Referee 3: Mirjam Blokker

First of all, the authors would like to thank the reviewer for taking valuable time to review and for the critical assessment of the paper.

Figure 1: Flow and shear stress data from referee comment section

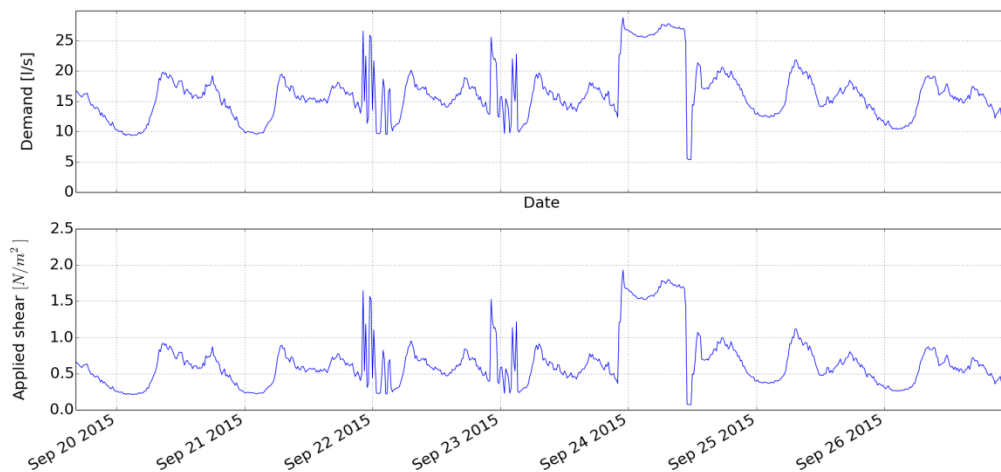
Comment 7: Fig 3: shear stress during ice pigging must be much higher, but is not easy to calculate. Instead, I would leave this part out to avoid confusion. What happened around 27 September (downstream pipe break?)? Caption should say 2015.

C7 Ans: We agree with the reviewer that estimation of shear stress due to the ice plug formation is hard, if not impossible.

A planned night time downstream network flushing was undertaken from 22nd September till 23rd September (2 nights). Also, there was a downstream burst event recorded as starting on 24th September and continuing until 25th September (figure 1). Unfortunately, we did not have any turbidity loggers deployed on this trunk main which could have captured the mobilisation response due to the burst event. These events could have mobilised accumulated material as it was higher than trial 2 event and potentially influence trial 3 responses. These event details have been added to the paper.
